35/13-98V 102 East Melrose Street
(Chevy Chase Village Historic District)

Case No. 35/13-98V Received September 30, 1998

Application of William J. and Sharon J. Clinton
102 East Melrose Street, Chevy Chase

DECISION AND OPINION OF THE COMMISSION

Drawing 1

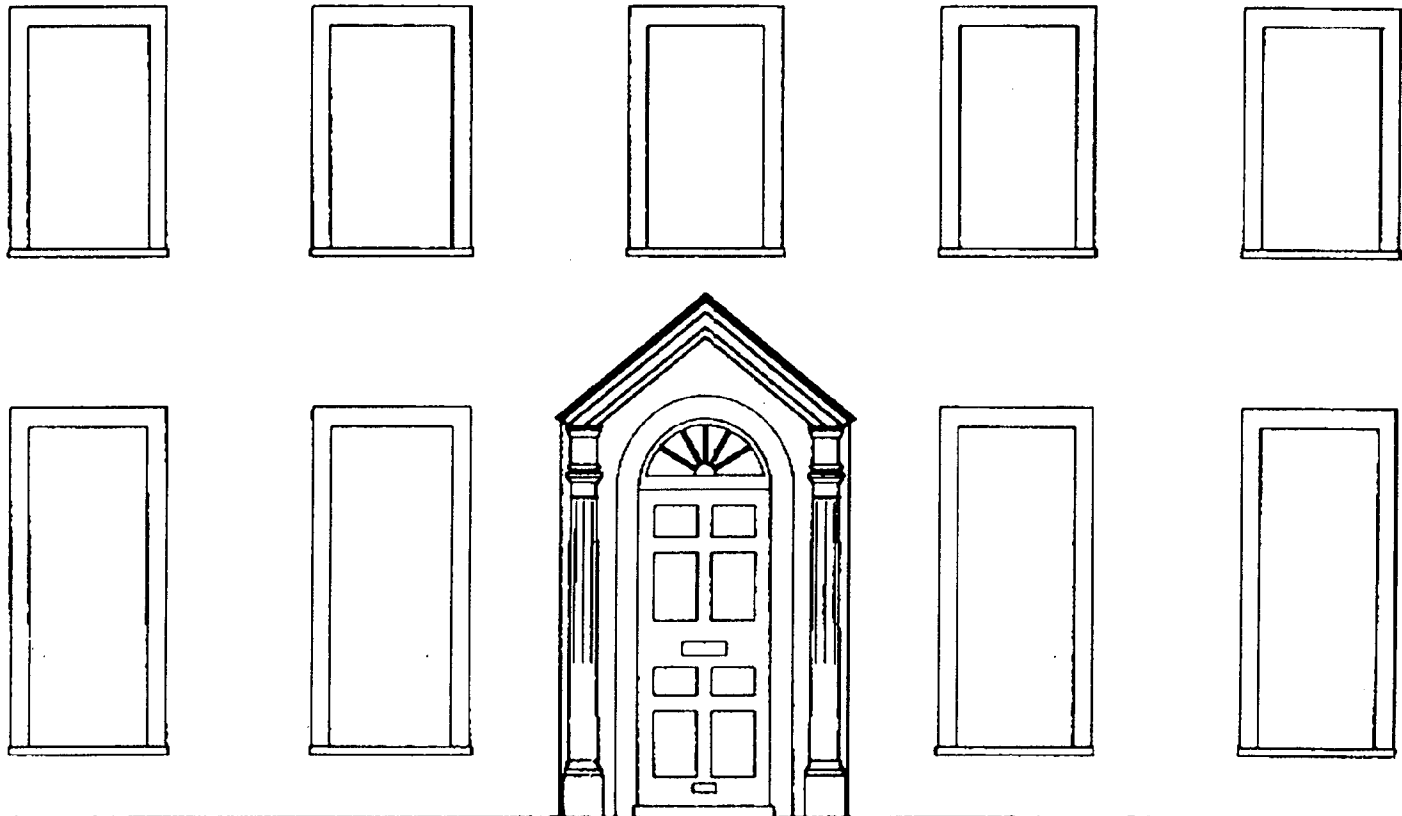
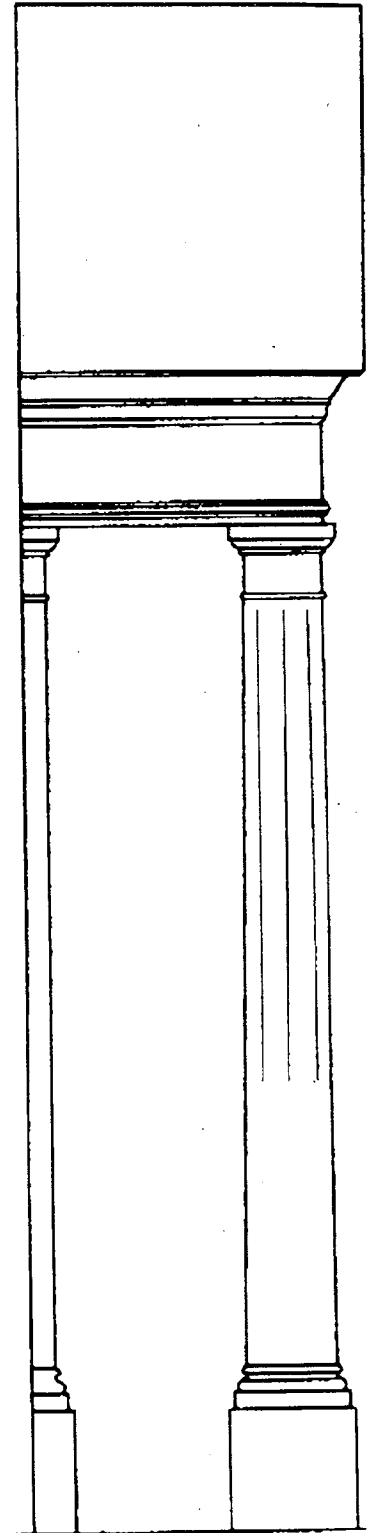
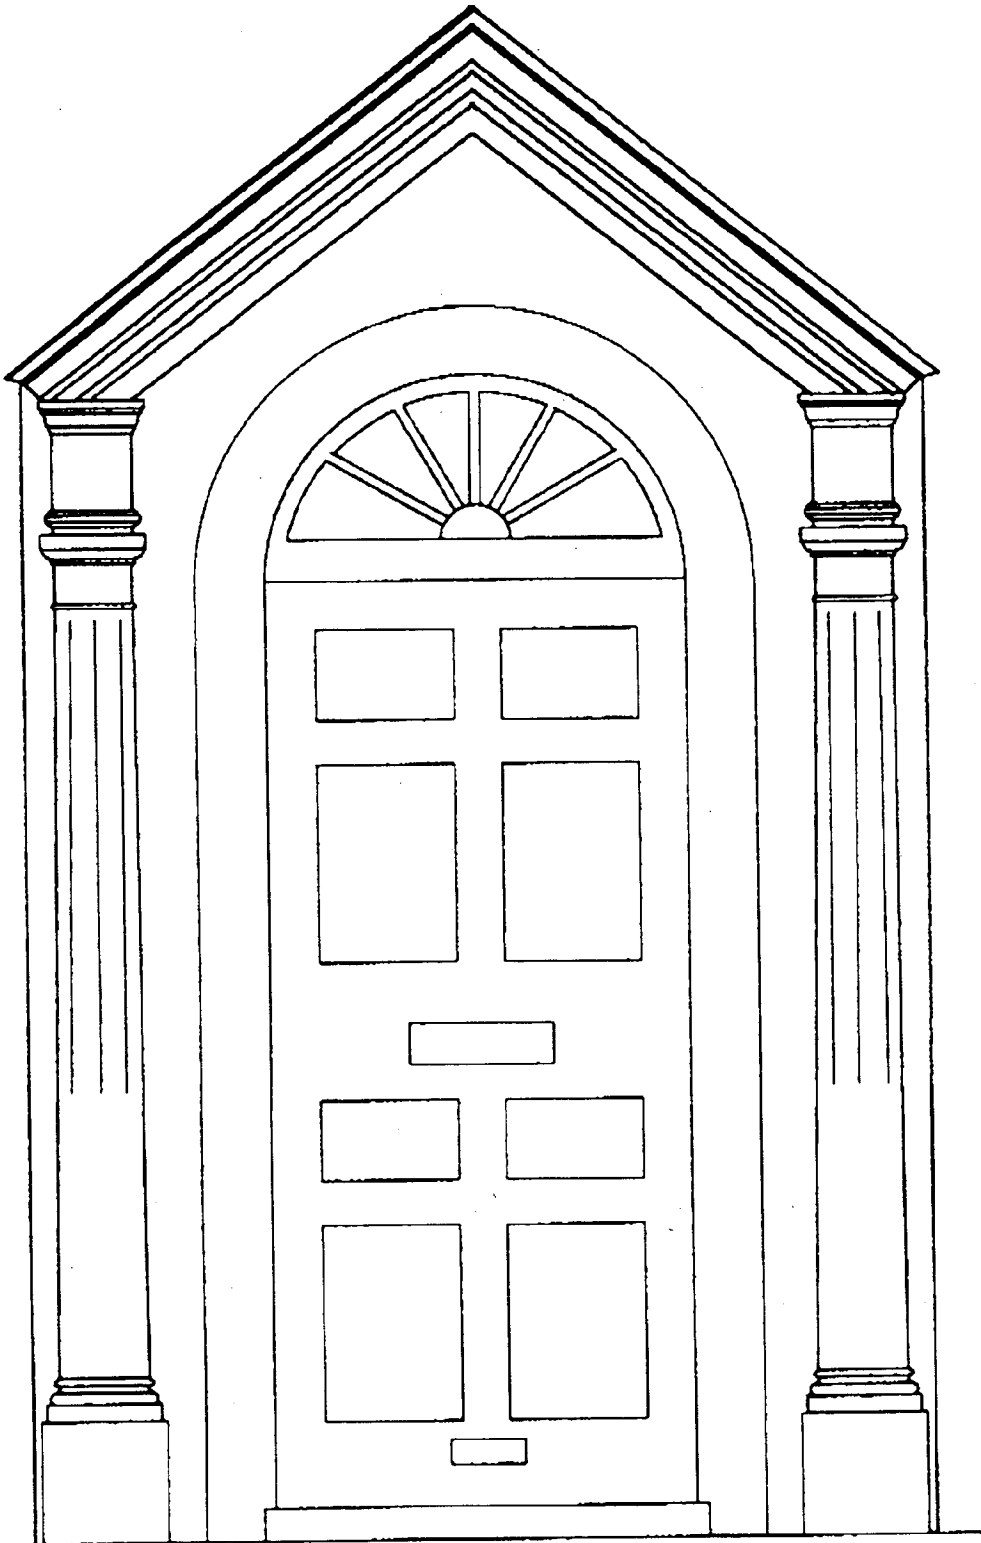
After reviewing the plans, it appears that the proposed construction will encroach approximately 6" into the 25' building restriction line, which violates the Village Building Code. The proposal may also be in violation of the covenants.

In original Federal buildings, the front entry treatment typically is the principal architectural detail on the front facade. This is also the case in Revival interpretations of the Federal Style and is exemplified in the subject property. The grand size and importance of the Federal Style is retained, but in a unique combination that simplifies at the same time it enhances the entrance. The unusual use of a semi-circular fanlight with a segmental or elliptical portico treatment and Tuscan columns, rather than using sidelights with an elliptical fanlight and a segmental portico is a Revival combination of two popular Federal period themes. Another design feature of the historic entry that is typical of the Revival Style is a flattening of the portico. The use of the more commonly occurring pedimented portico has been conspicuously avoided.

The applicant has also indicated that they originally designed the portico to provide more shelter for the front entrance. As the design has been modified from 2'6" to 2' to avoid encroaching on the 25" building restriction line, shelter is only moderately improved by the proposed change from the existing portico.
